Final of the Project Coordination Plan
for the Sampling of Soils Below Floor Slabs at LLs-2,3,4 and
Excavation and Transportation of Contaminated Soils to Load Line
4 (Buildings G-1, G-1A, and G-3)

Ravenna Army Ammunition Plant
8451 St. Route 5
Ravenna, OH 44266-9297

**DRAFT PROJECT COORDINATION PLAN FOR
THE SAMPLING OF SOILS BELOW FLOOR SLABS AT LLS-2,3,4 AND EXCAVATION & TRANSPORTATION OF CONTAMINATED SOILS TO
LOAD LINE 4 (BUILDINGS G-1, G-1A, AND G-3)
COMMENT RESPONSE TABLE
MARCH 11, 2008**

Figure 5-1
 Project: RVAAP Sub Slab
 Date: Thu 3/13/08

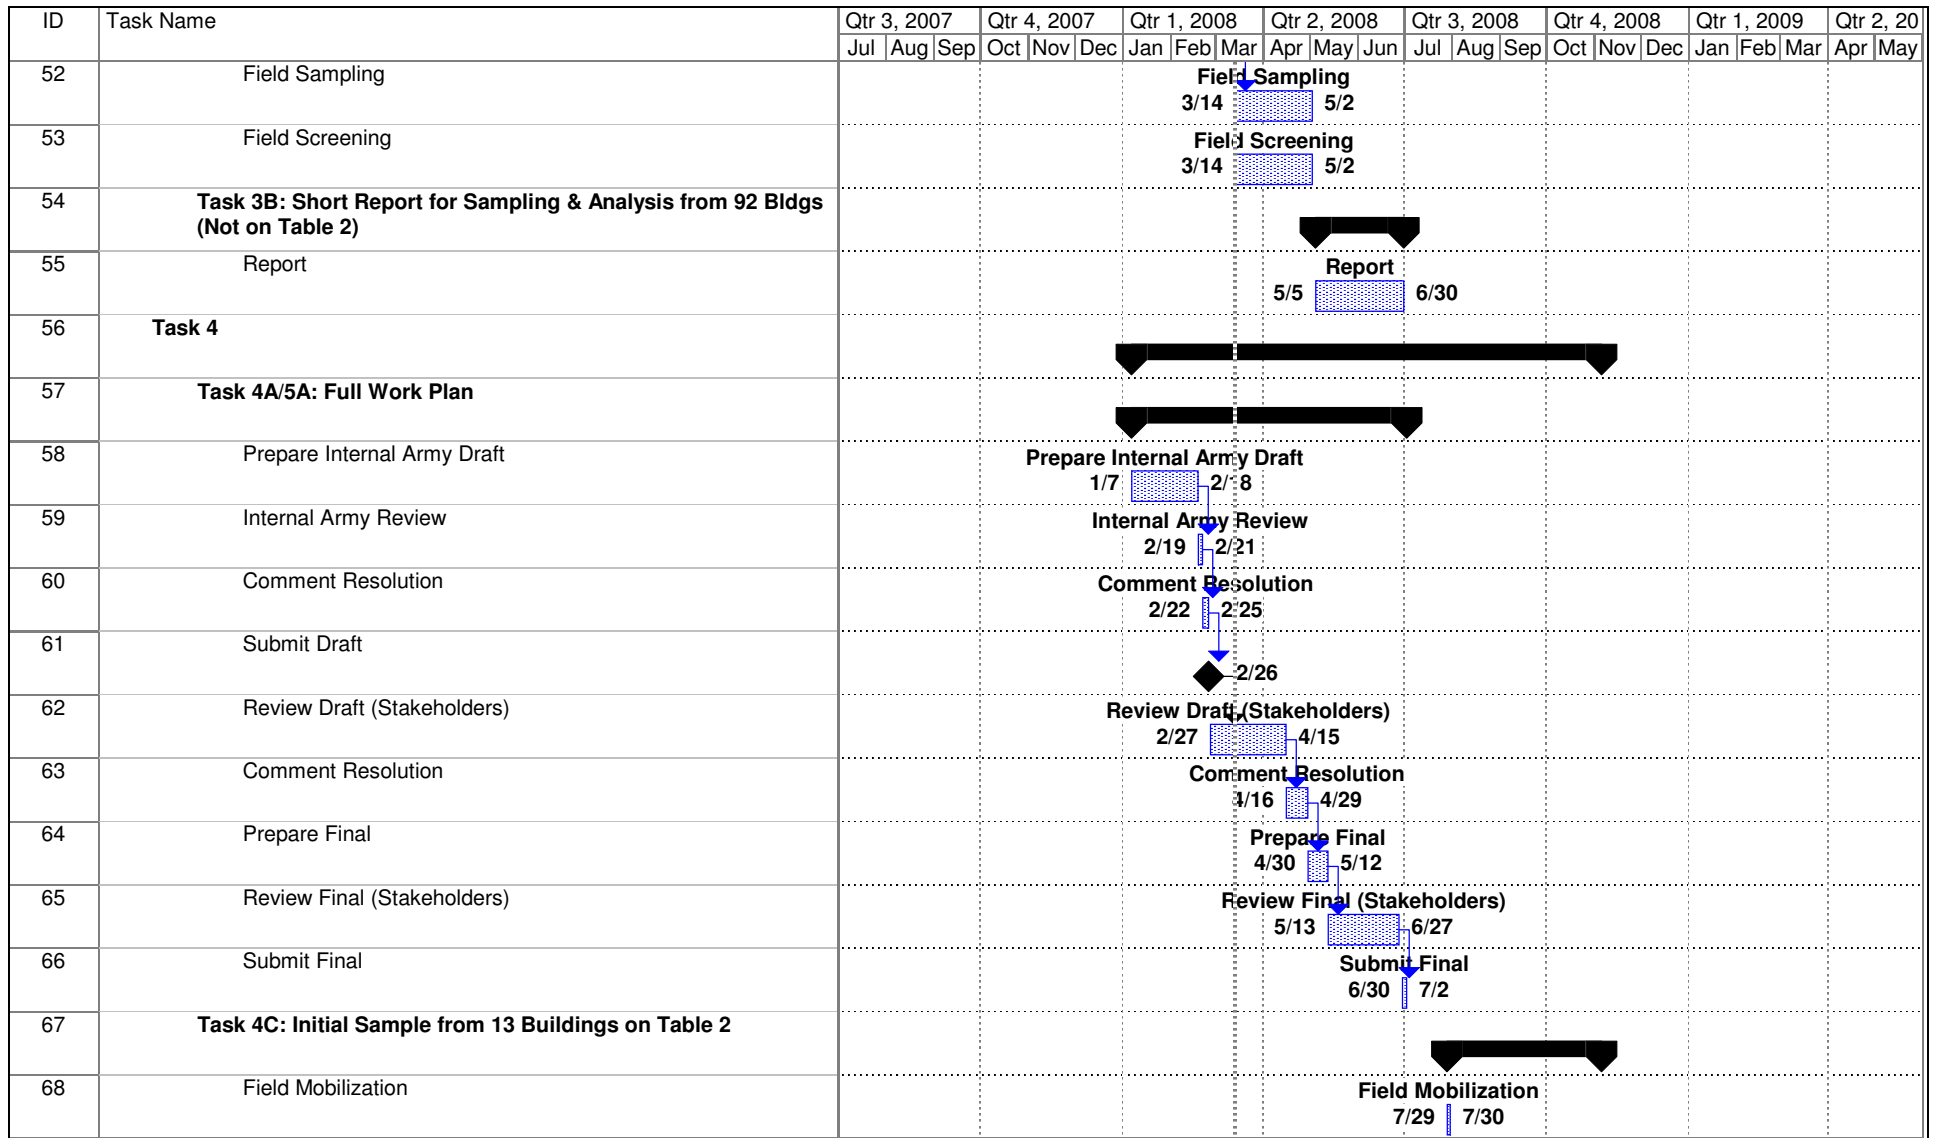
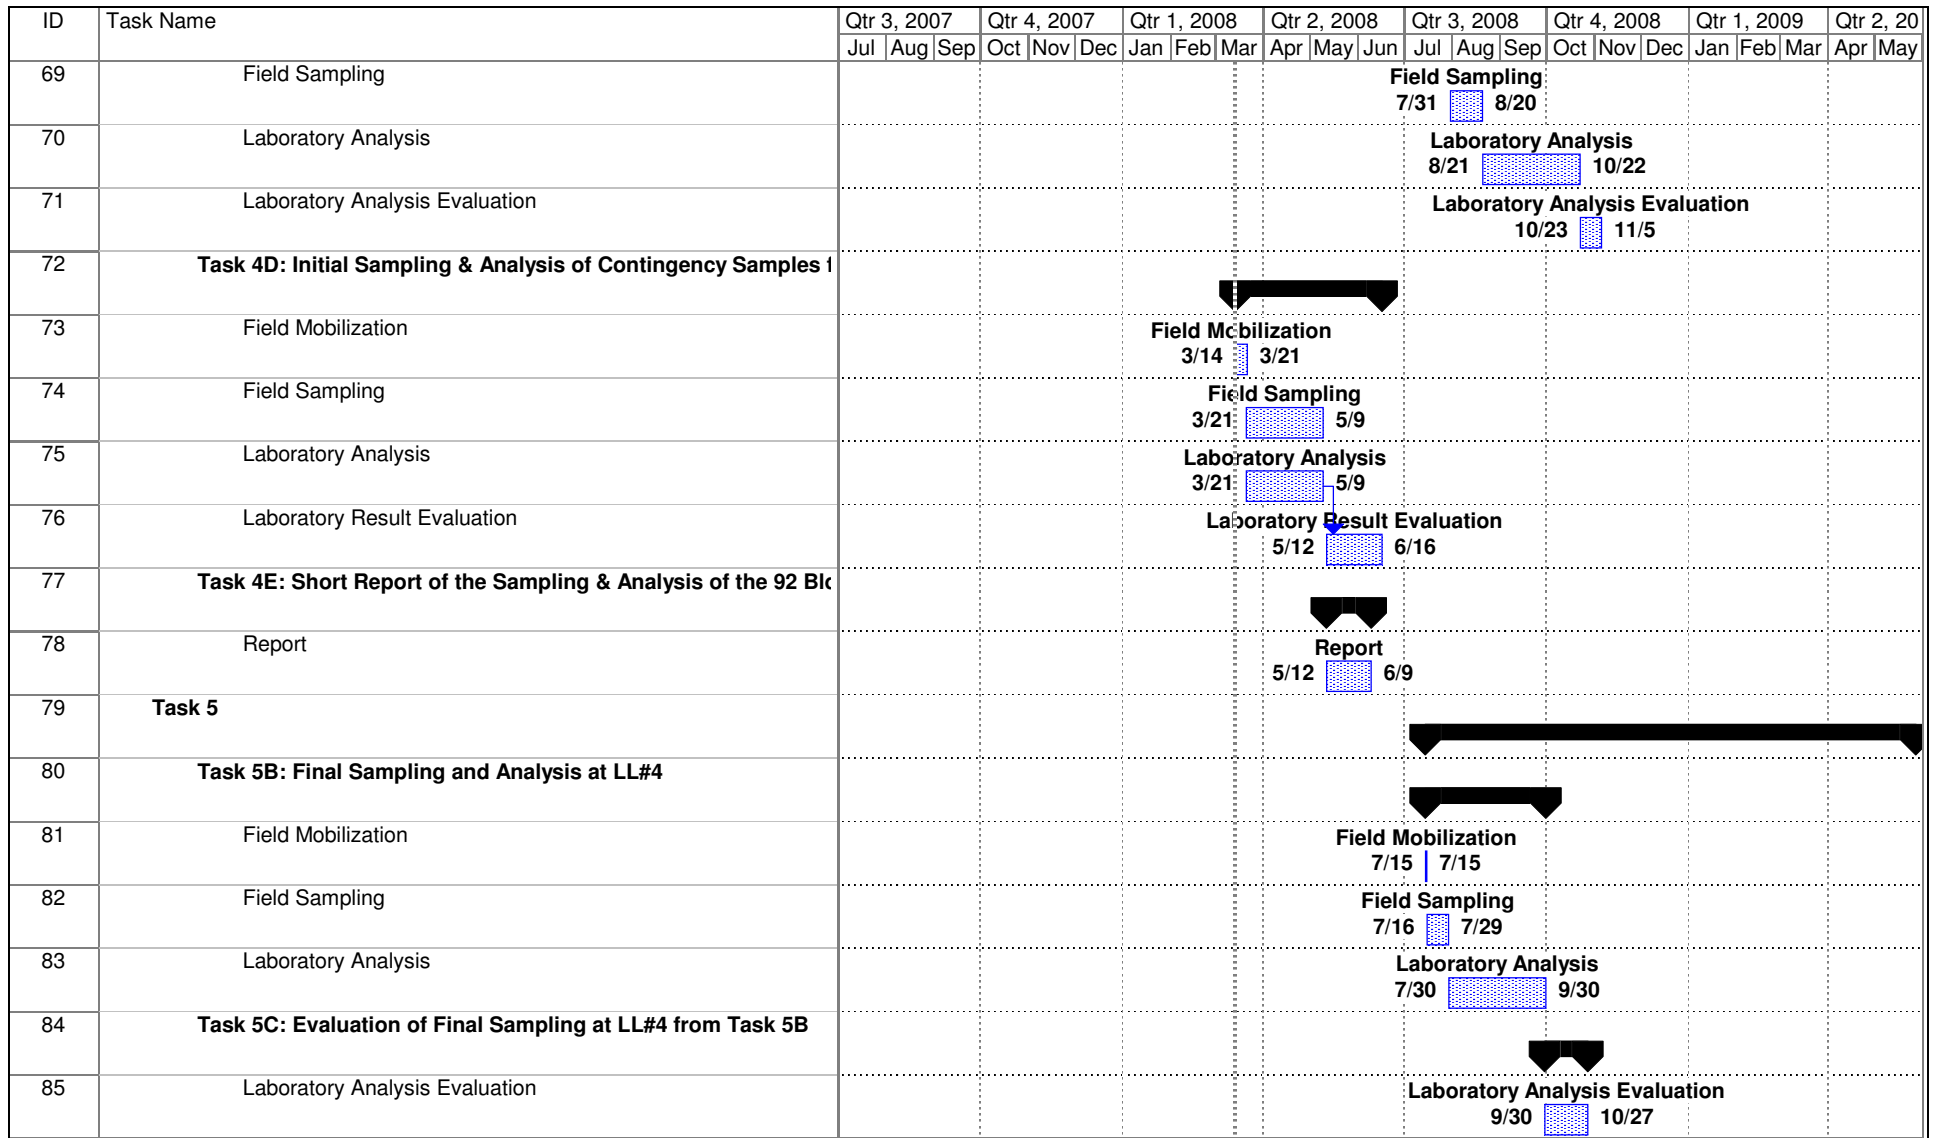
Comment Number	Page No/ Line No.	Comment	Recommendation	Response
	pg. 2	2B/4B/6A: The ESS can be adjusted, as Ohio EPA previously indicated that we did not need to review the revised ESS. (Specifically, adjust the schedule to account for USATCES reviews, not the 45 day Order clock.)		revised to reflect actual dates. Stakeholder review has been deleted from this task.
9.	Schedule, pg. 3	Tasks 2E and 2F need to be accelerated. The letter workplan and health and safety plan (HASP) are in place. There is no need to hold off on the sampling and disposal of the six (6) soil piles.		Since the letter Work Plan and HASP are in place and approved, the schedule for Tasks 2E and 2F have been accelerated. The schedule has been updated to reflect a March 14, 2008 date to begin the sampling. The revised schedule included in the final PCP is current as of March 11, 2008.
